TECHNICAL SERVICE BULLETIN																	
DATE ISSUED		MODEL YEAR(S) AFFECTED		MODEL(S) AFFECTED		TSB #											
3/24/08		2006-2007		All Newmar DP on Spartan MM Chassis		335											
BRAND						TYPE											
All	☐	American Star	☐	Mountain Aire	☐	All	☐ TT ☐										
Cypress	☐	Dutch Star	☒	Kountry Aire	☐	FW	☐ CA ☐										
Northern Star	☐	Kountry Star	☒	Essex	☐	DP	☒ DB ☐										
Scottsdale	☐	King Aire	☐	London Aire	☐												
All Star ME	☒	Ventana	☒

RSB07-500-002

RECALL SERVICE BULLETIN

SUBJECT: Power Distribution – Bussmann® (DVEC) Dual Vehicle Electrical Center.

FIG. 2-1

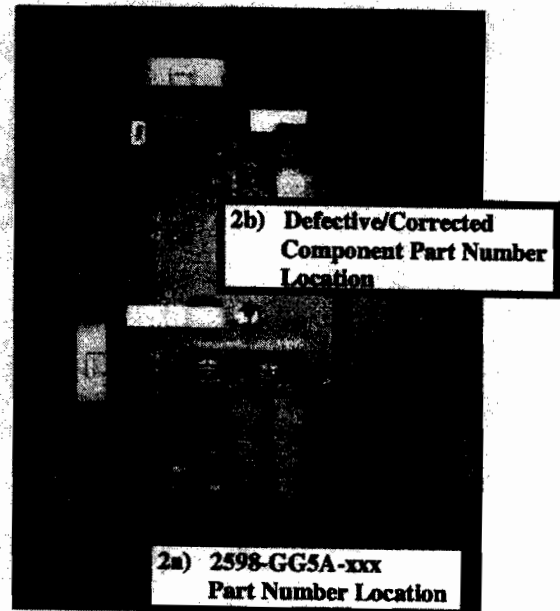
1. Observe all industry safety standards, disconnect any necessary power source and secure vehicle to allow for replacement of the Bussmann® DVEC at the rear PDC (Power Distribution Center).
2. Locate the rear PDC near the engine, generally on the passenger side between the rear wheels and the rear of the vehicle.
 - 2a. Refer to FIG. 2-1. Identify the DVEC having a part number beginning with 2598-GG5A. The part number is located on the inside cover and on the lower right inside face of the box.
 - 2b. Refer to FIG. 2-1, 2-2 & 3-1. The DVEC having a part number in the top right corner of the box ending in a -1 is defective and must be replaced with a box where this number ends in -2 as shown in FIG. 3-1.
